**Revision 6 of the San Onofre Nuclear Generation Station  
(SONGS) Offsite Dose Calculation Manual (ODCM),  
SO123-ODCM**

SUBJECT: Revision 6 of the San Onofre Nuclear Generating Station (SONGS) Offsite Dose Calculation Manual (ODCM), SO123-ODCM.

Enclosed is Revision 6 to the SONGS Offsite Dose Calculation Manual (ODCM). This revision incorporates the following: 1) Land Use Census changes, 2) update of North Industrial Area on Exclusion Area Boundary drawing, 3) revised liquid effluent radiation monitor calibration constants, 4) changes to Radiological Environmental Monitoring Program, and 5) addition of supplemental information to Appendix B.

Figure 2-2

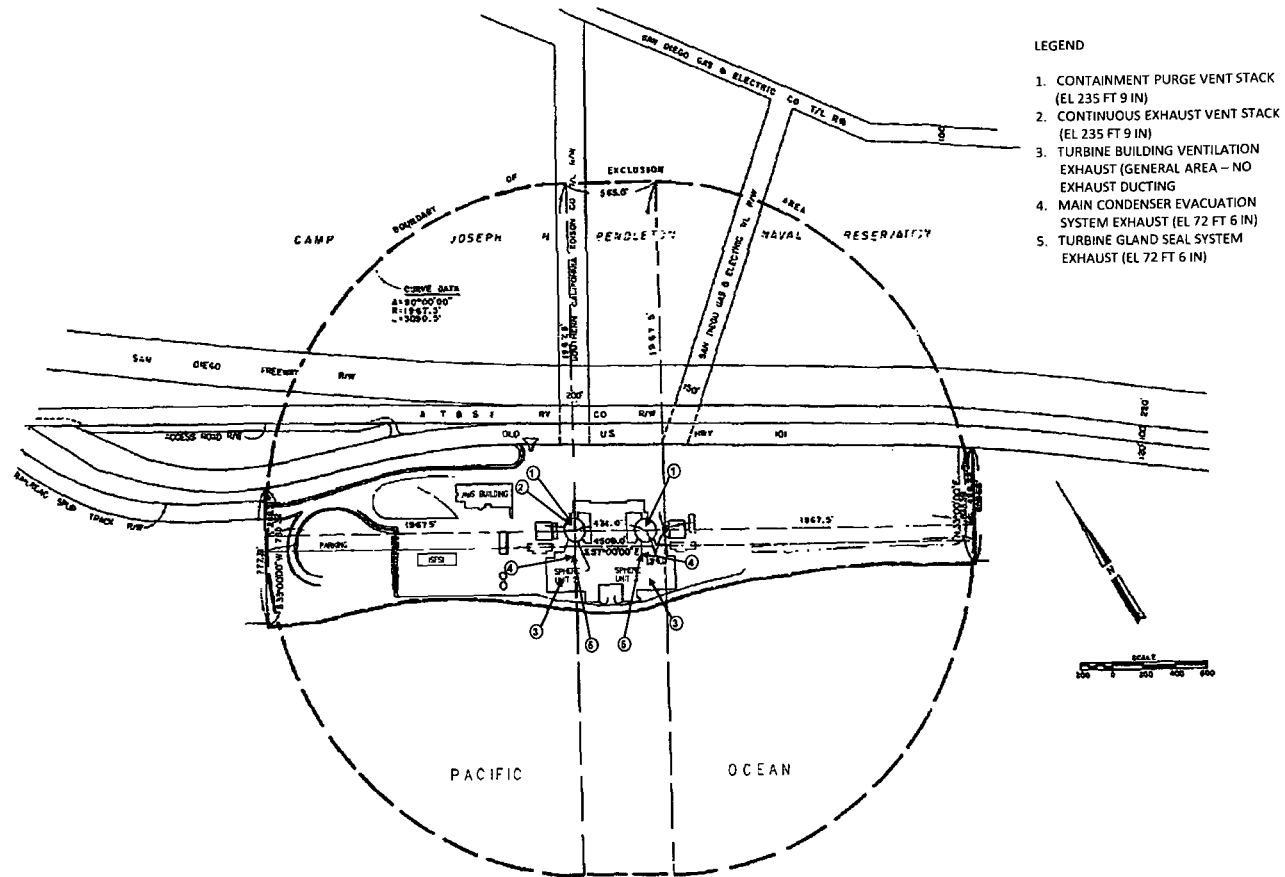
<b>Page #</b>	<b>changes due to new revision</b>	<b>Reason</b>
Title Pages	Revised from previous revision to Rev 6	R
1-23	Revised Liquid Effluent Radiation Monitor Calibration Constants	R
2-9	Revised Figure 2-2, SONGS Site Boundary for Gaseous Effluents, deleting Unit 1 and the Reservoir	R
2-29	Revised U2&3 Controlling Location Factors, per Land Use Census	R
5-23	Revised Figure 5-1, adding missing sample locations, Non-Migratory Marine Animals A and Ocean Bottom Sediment F.	R
5-24	Revised Figure 5-2, adding missing sample locations, Non-Migratory Marine Animals A and Ocean Bottom Sediment F.	R
5-25	Revised Figure 5-3, adding missing sample locations, Non-Migratory Marine Animals A and Ocean Bottom Sediment F.	R
5-26	Revised Figure 5-4, adding missing sample locations, Non-Migratory Marine Animals A and Ocean Bottom Sediment F.	R
5-27	Replaced Figure 5-5, Improving clarity	F
